Subject: Liaison Statement to 802.16 on clarification and corrections to the IEEE 802.16 draft standard needed to support WiMAX certification.

WiMAX TWG LS to 802.16 WG, Annex A

Figure 229c—HARQ downlink allocation

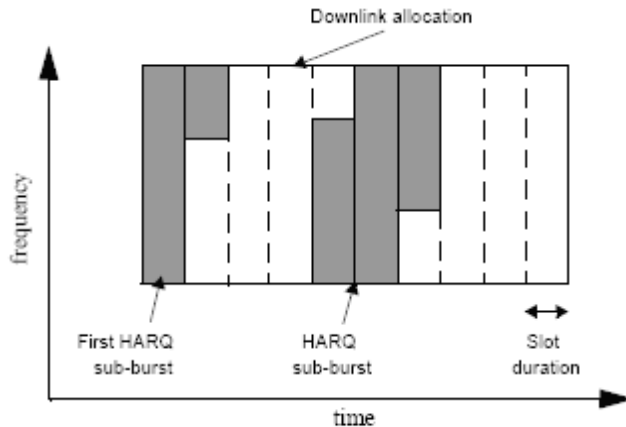
Moreover, for the downlink, HARQ ACK disabled/enabled burst is assigned with 1D allocation as shown in Figure 229c of the standard, which may not have a rectangular shape but may have a snake-shape, while the normal(non-HARQ) burst allocated with normal DL_MAP_IE is always allocated with rectangular shape(2D).

The HARQ ACK disabled burst allocated with HARQ_DL_MAP_IE with “ACK disable”=1 or HARQ_UL_MAP_IE with “ACK disable”=1 should be treated as a HARQ burst (Option 1) or a non-HARQ burst (Option 2) when counting the number of DL/UL bursts per frame per MS.

- Option 1 : Treat the HARQ ACK disabled burst as a HARQ burst (without retransmission) and count it accordingly as one HARQ burst when BS allocating bursts within the limitation of maximum bursts per frame per MS.
- Option 2 : Treat the HARQ ACK disabled burst as a normal(non-HARQ) burst and count it accordingly as one non-HARQ burst when BS allocating bursts within the limitation of maximum bursts per frame per MS.

The group recommends Option 2 as a remedy.
